SUBJECT: CATAWBA NUCLEAR STATION - FINAL ACCIDENT SEQUENCE PRECURSOR
ANALYSIS OF EVENT AT CATAWBA NUCLEAR STATION, UNIT 2 (TAC M95254)

LER No. 414/96-001

Event Description: Loss of Offsite Power (LOOP) with Emergency Diesel Generator (EDG) B Unavailable

Licensee Comments

Fig. 2 Fault tree modeling the Standby Shutdown Facility (SSF).

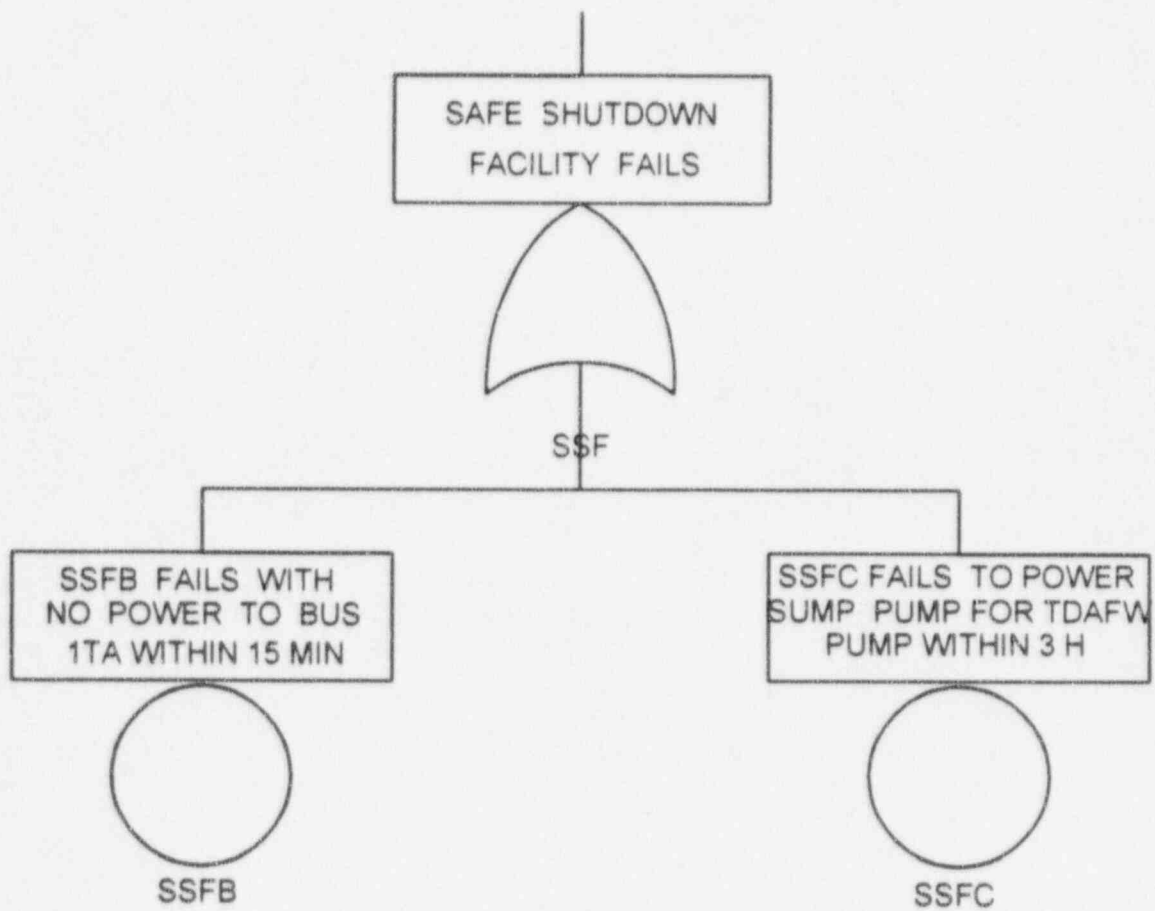
Comment 3a: The preliminary ORNL analysis attempts to include the Standby Shutdown Facility (SSF) feature to mitigate a loss of all ac power condition. However, inclusion of both the SSFB and SSFC logic is not correct. The SSFC cut sets are a subset of the SSFB cut sets. (Please see Table A. 18-7 of the Catawba IPE.) The main differences between SSFB and SSFC are that (i) SSFB requires operator action within 15 minutes, while for the SSFC case, action can be delayed for up to 3 hours, and (ii) SSFB contains additional failure modes involving the Reactor Coolant pump seal injection components. In the Catawba Probabilistic Risk Assessment (PRA), success of SSFC does not prevent a core melt; it simply changes the plant damage state.

Comment 3b: In addition, cut sets representing unavailability of the SSF due to maintenance ($2.57\text{E-}2$) and maintenance on the SSF diesel generator ($2.96\text{E-}3$) could be deleted when determining the probability associated with SSFB, since this equipment was available during the event.

Comment 3c: Thus SSFC cut sets and SSF maintenance events should be deleted from the ORNL preliminary analysis. Incorporating these suggestions results in an SSF failure probability of 0.19.

Response 3a: The original fault tree model of the SSF was misleading. The original figure (Fig. 2) simply had "SSF" without identifying "B" or "C." This has been corrected. The placement of the SSF in the event tree (Fig. 1) is such that the SSF is not needed to mitigate core damage until the remaining EDG

fails (EDG 2A) and the turbine-driven AFW pump starts and runs successfully. As indicated on page 35 of Figure A.5-7 in the AFW system fault tree for the Catawba IPE, SSFC is used to ensure power to the turbine-driven pump (TDAFWP) pit sump pump (sump pump 1A1) given a station blackout (SBO) condition. A station blackout would have occurred if EDG 2A failed during this event. Because the motor-driven AFW pumps are unavailable, success of the AFW is dependent on the success of the TDAFWP. The success of the TDAFWP is now dependent on the SSFC to provide power to the TDAFWP pit sump pump because the TDAFWP oil cooler flow and a portion of the turbine seal water empties directly into the pit for the TDAFWP. SSFC must be available within 3 h before the leakage or the water accumulation in the TDAFWP pit would fail the pump. The SSFB, on the other hand, is modeled as providing seal cooling in the event of a station blackout. Specifically, page A.18-15 in the SSF insight section for the Catawba IPE indicates that SSFB is used to provide a means of seal cooling to prevent a seal LOCA in the event of an SBO. SSFB must be available within 15 min of station blackout. The ORNL analysis is consistent with the Catawba PRA.

Response 3b: Because a component successfully performed its function during an event is no reason to reduce or change the failure probability or unavailability of that component. Similarly, it is inappropriate to remove the unavailability due to potential maintenance activities on these components just because no maintenance was being performed on them during the event.

Response 3c: Based on the responses to 3a and 3b, the SSF model appears to be appropriate, and no changes were made to that portion of the analysis.

Fig. 3 Fault tree modeling the recovery of offsite power before the core becomes uncovered given a seal LOCA (OP-SL).

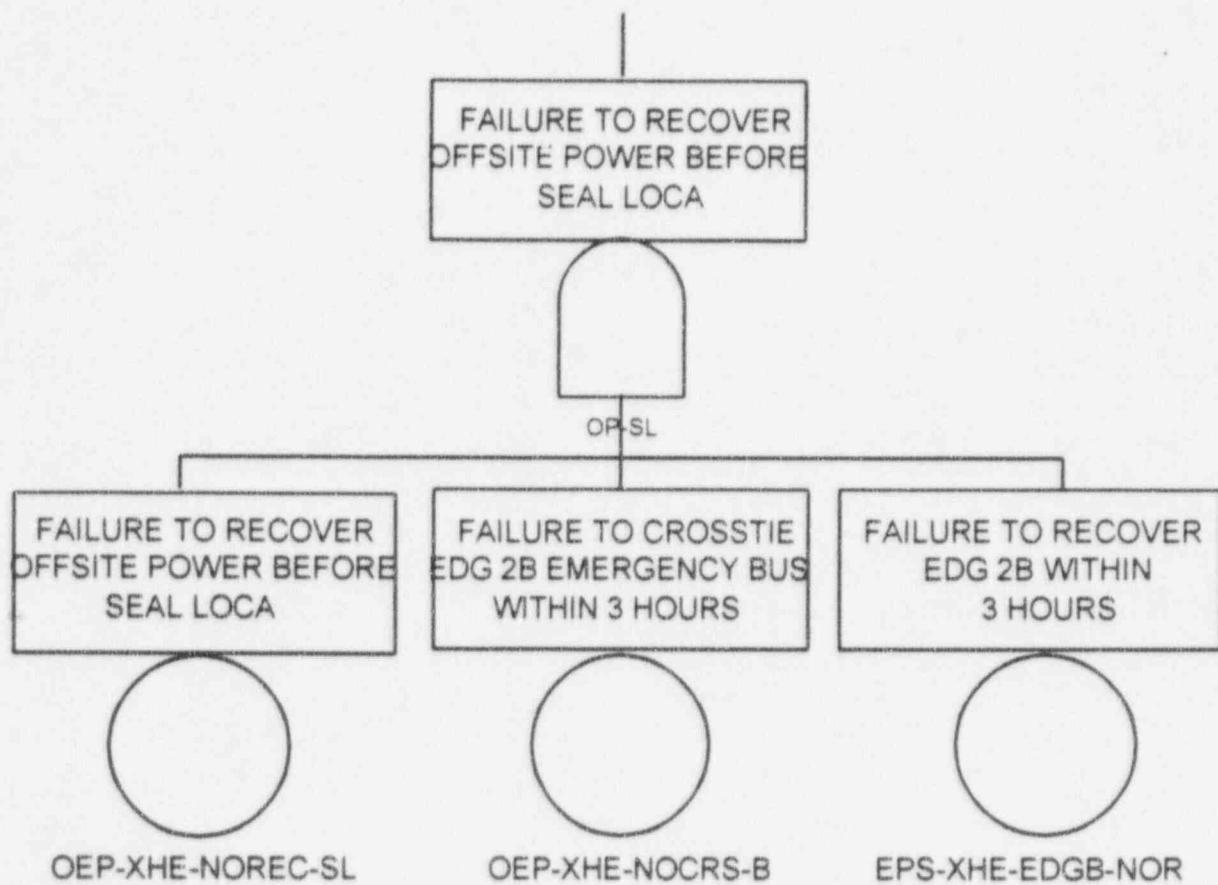
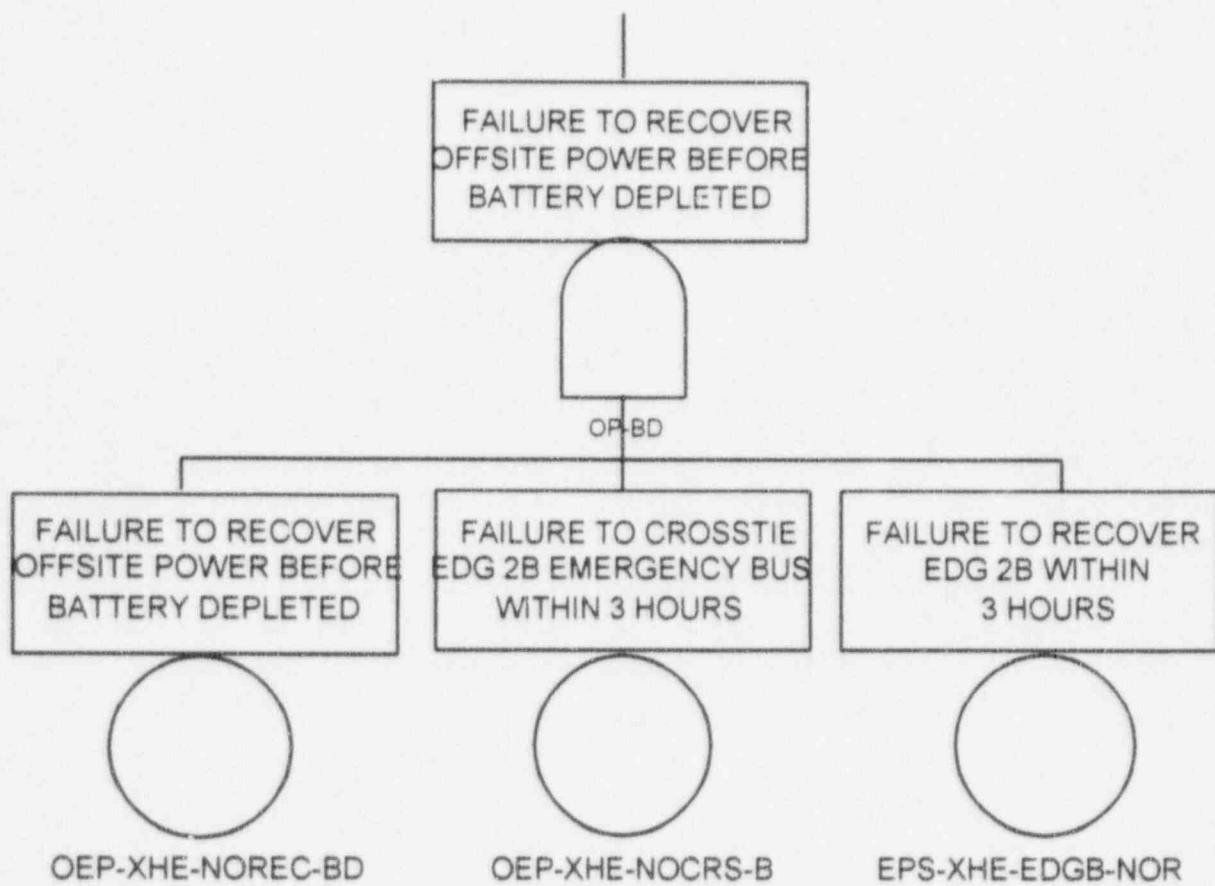
Comment 1: In the preliminary ORNL analysis only Emergency Diesel Generator (EDG) 2A was considered available for the mission time (7.5 hours) of interest. EDG 2B, which was in maintenance at the time of the event but returned to service at about 3 hours, is treated as in maintenance but potentially recoverable, with a recovery probability of 0.48. [This is basic event EPS-XHE-EDGB-NOR.]

An alternate approach, which perhaps more closely resembles the actual post-event condition, would be to consider only one EDG to be available during the first three hours, with potential recovery of the other EDG, and both EDGs to be available subsequently. Attachment B [of McCollum's letter] presents the development of the dominant related sequence.

At the time of the event, EDG 2B was out of service to perform maintenance on the EDG 2B battery charger. In the event EDG 2B was needed after the LOOP event because no other source of ac power was readily available, plant personnel would have attempted to place EDG 2B into service by clearing the out-of-service tags and closing the breakers. EDG 2B battery is considered to have adequate capacity to start the EDG without the charger. The estimated time to place EDG 2B into a functional status for this scenario is estimated to be in the range of 1 to 1.5 hours. Since EDG 2A was supplying the load, EDG 2B was not needed. It was placed into operation at 2 hours and 51 minutes after the initiating event.

Response 1: The modeling approach taken assumes that EDG 2A is available with a failure probability of 0.045 (EPS-DGN-FC-1A). Not only is the ability to recover EDG 2B within the first 3 h of the event considered (EPS-XHE-EDGB-NOR), it also credits the potential for restoring offsite power (OEP-XHE-NOREC-SL and OPE-XHE-NOREC-BD) and for powering the Unit 2 emergency bus by EDG 2B from the corresponding Unit 1 emergency power bus (OEP-XHE-NOCRS-B) (see Figs. 3 and 4). The Unit 1 emergency power bus remained powered from its normal offsite ac power source.

The nonrecovery probability of 0.48 for EPS-XHE-EDGB-NOR was obtained using a value of 140 min as the median time to repair EDG 2B with a 30-min delay to allow for the decision process to decide to repair EDG 2B. Based on Comment 1, this repair time was adjusted to 90 min with a 30-min delay required for the decision process to reach completion. The value of 3 h for the time available to restore EDG 2B (in case EDG 2A becomes unavailable) was based on the ability of the Standby Shutdown Facility (SSF) to prevent a seal-LOCA and the turbine-driven AFW pump to provide feedwater for decay heat removal. Using the exponential repair model with a repair time of 90 min and a 30-min delay, in combination with the time available to restore EDG 2B (3 h), results in a revised nonrecovery probability of 0.31 for EPS-XHE-EDGB-NOR.
